MUNICIPAL CORPORATION,
KARACHI

ORDER UNDER SCH. VI, CHP. XI, RULE 5 (1) OF
ACT XVII OF 1933.

PROPOSED ADDITION OF 1ST & 2ND FLOORS.
PROPOSED PLAN OF BUILDING ON PLOT NO 23, SHEET NO M.M.I.
MACHHI MIANI QUARTER
 SCALE 8 FT TO AN INCH.

With reference to your application dated 16-5-38
with a plan for the proposed buildings/additions and alterations on plot
No. 23 Survey Sheet No. M.M.1, Machi Mian quarter,
I have to request you to comply with the following requirements:—

GROUND FLOOR PLAN.

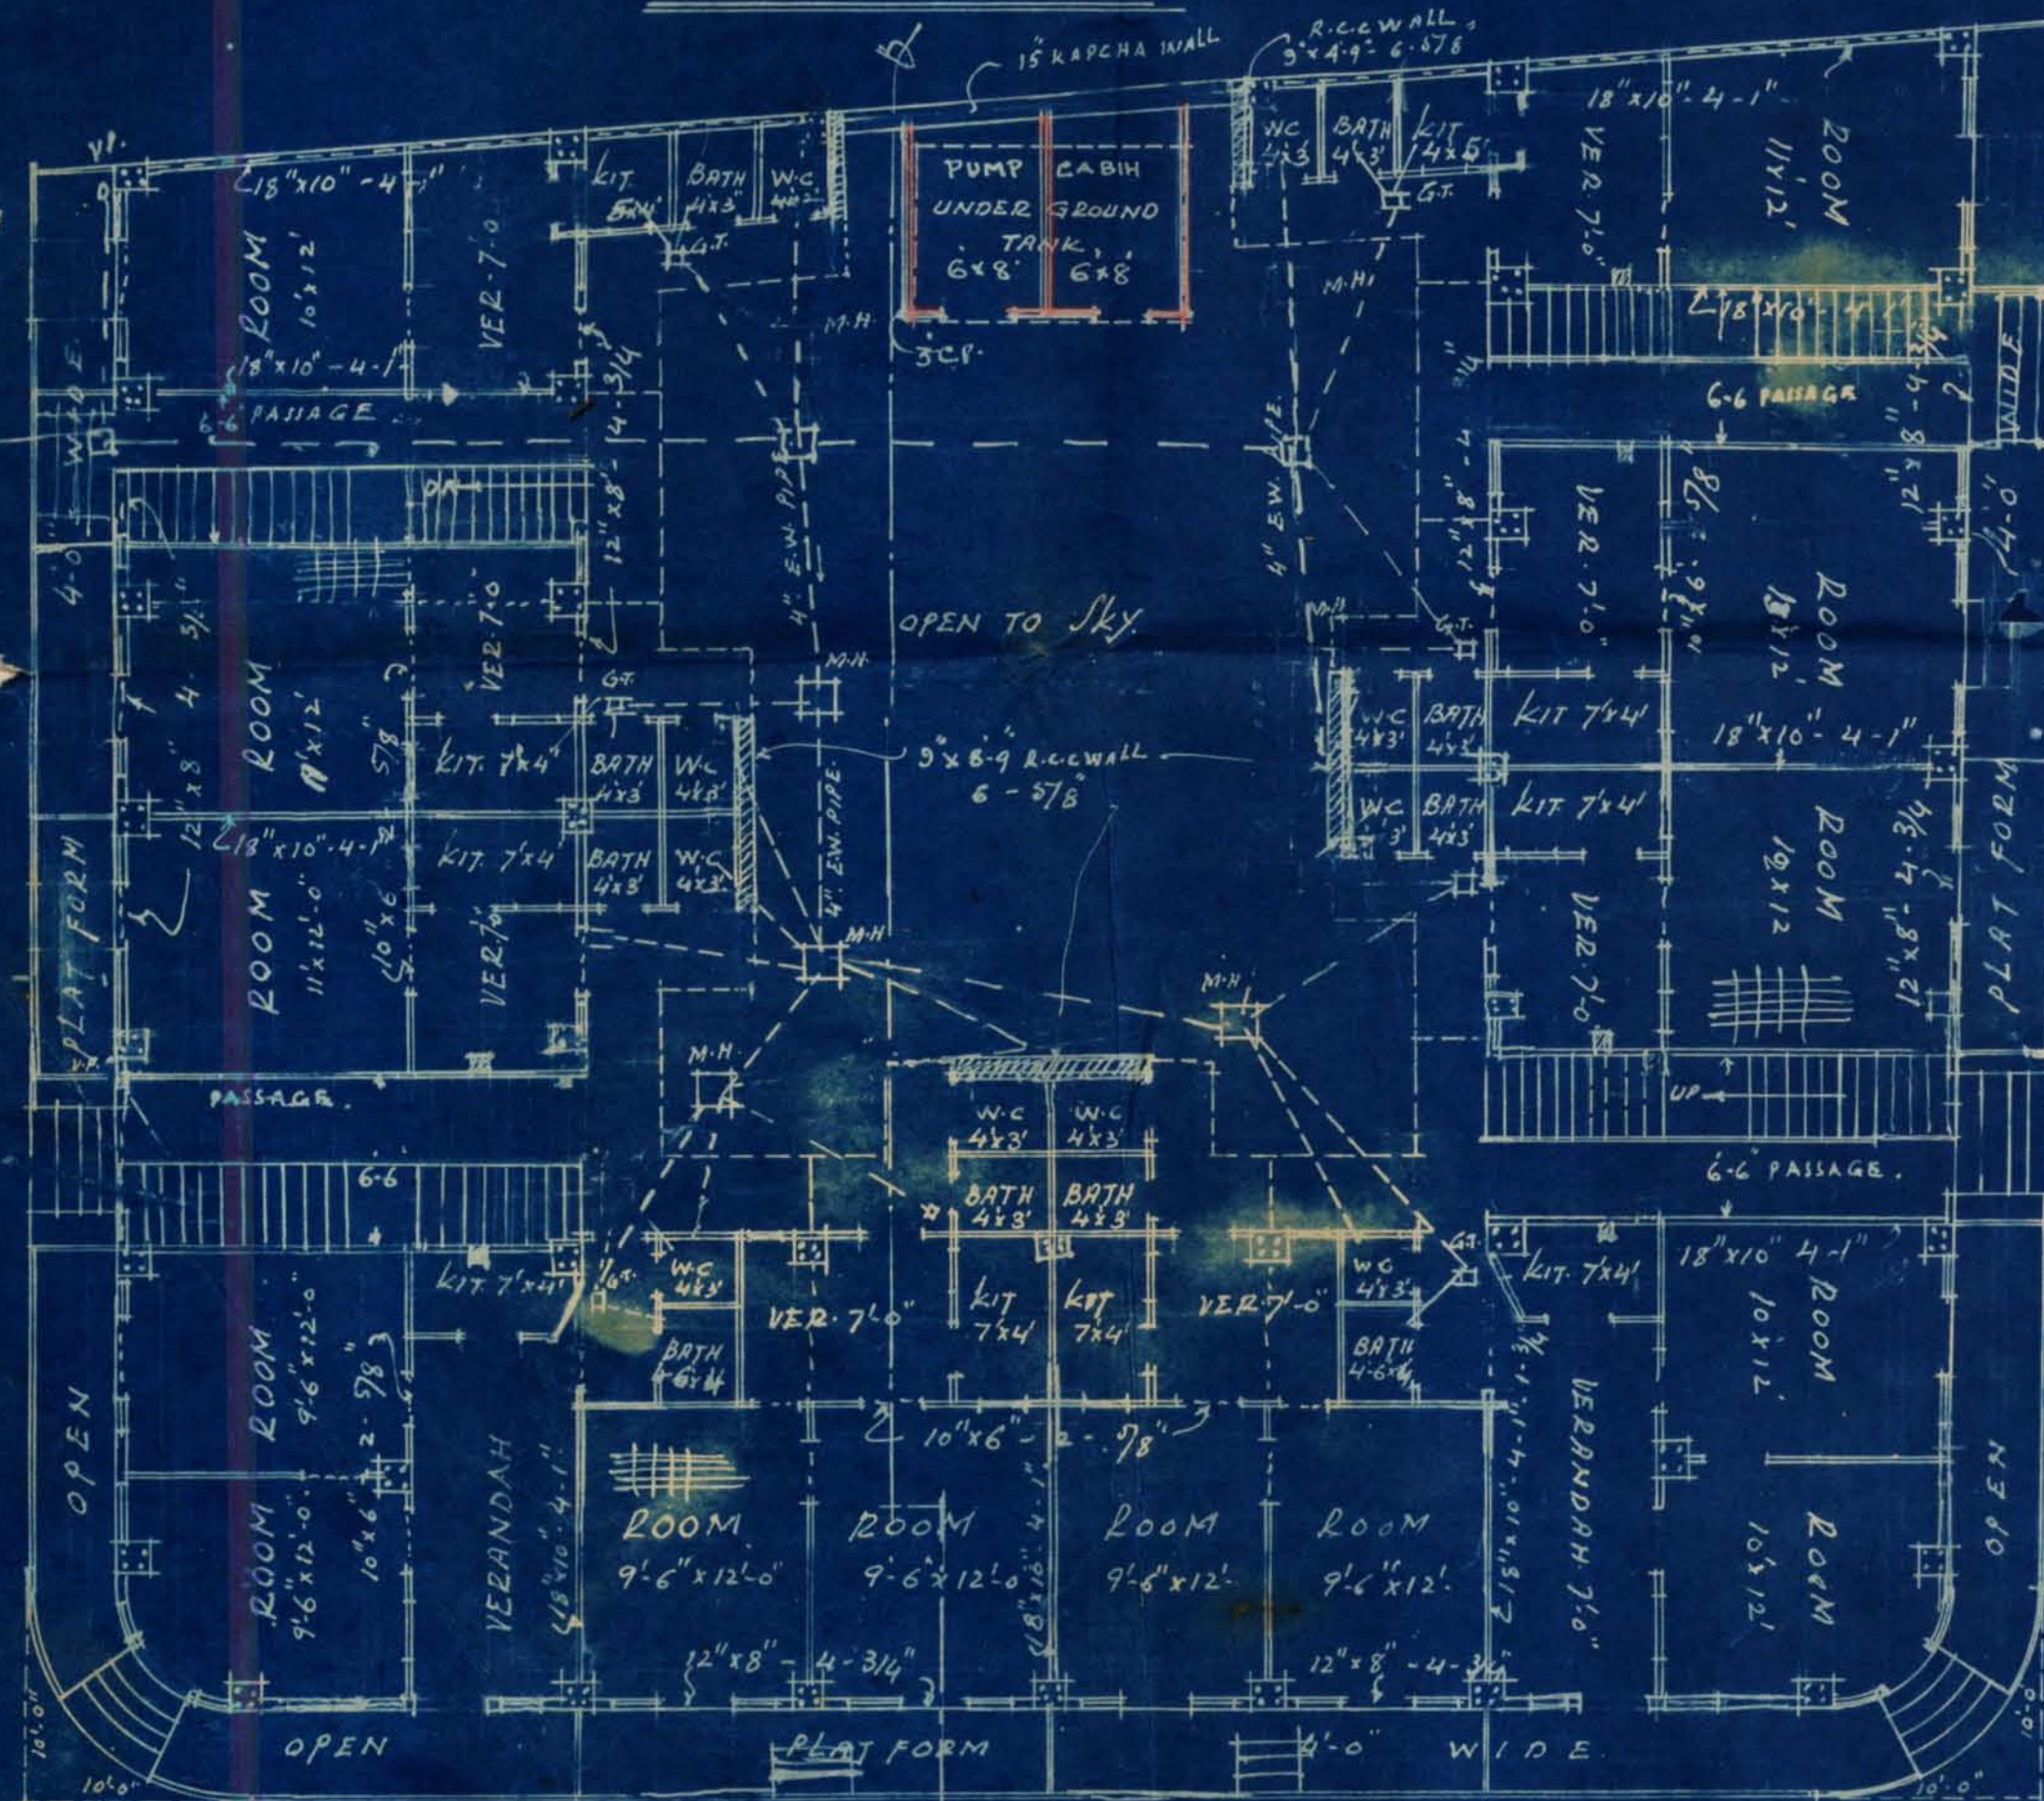
I am herewith sending you two copies of plans
for electric pump Cabin on the above plot.
There is no other change from the plans already
approved. The permission is sought for pump
room as shown on the plans to the other
side.

SECTION THROUGH PUMP CABIN.

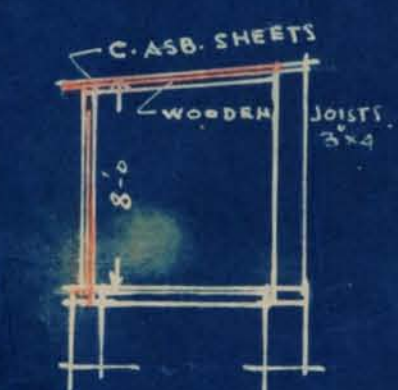
With reference to your letter no L.C.P.670/37 dated
25-5-38, I have to bring to your kind notice that
such cabins for pumps are being allowed in free
area throughout the City. Under the circumstances
the objection may please be waived and the cabin
may be allowed in free area.
A copy of plan is returned herewith.

Forwarded with Compliments to the
Chief Officer for sanction of orders if the cabins
for electric pumps shown red in the accompanying
plan be allowed as open to sky. Such cabins have been
allowed in open area with sanction of C.O. S. B. Perumal
not to be obtained in general.

1. As permissible built up area will be exceeded by the proposed construction of pump cabin, it can not be allowed.

As permissible
As there is no built up
area will be exceeded by the
proposed construction of pump
Cabin, it cannot be allowed

Plans approved
Take allowed open
to sky and it should
be sufficient only
to house the
pump etc
